TECHNICAL SERVICE BULLETIN

3 B 2

DISTRIBUTOR WATERPROOFING

AUSTIN AMERICA

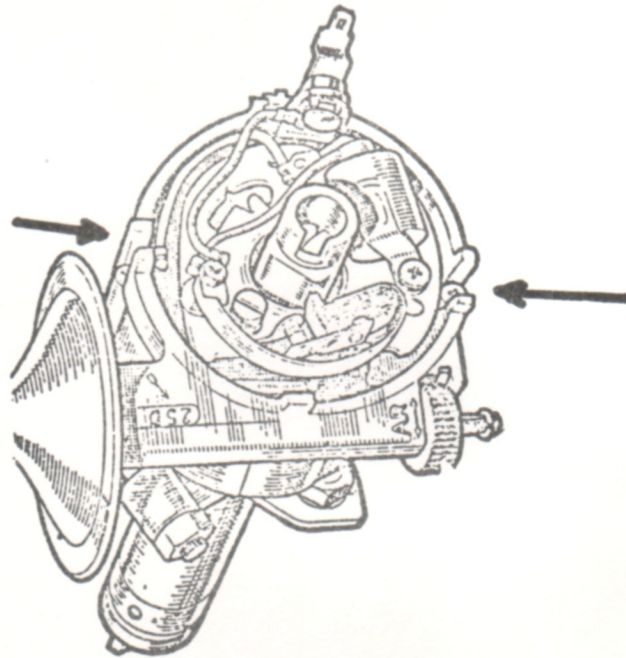
To improve waterproofing of the distributor. Seals, Lucas part number 54420573 may be fitted in the slots of the distributor housing as indicated below.

Additionally, ignition lead kit HAC 651 should be fitted to vehicles prior to serial number AA2SD 30822 when ignition breakdown caused by water ingress is experienced.
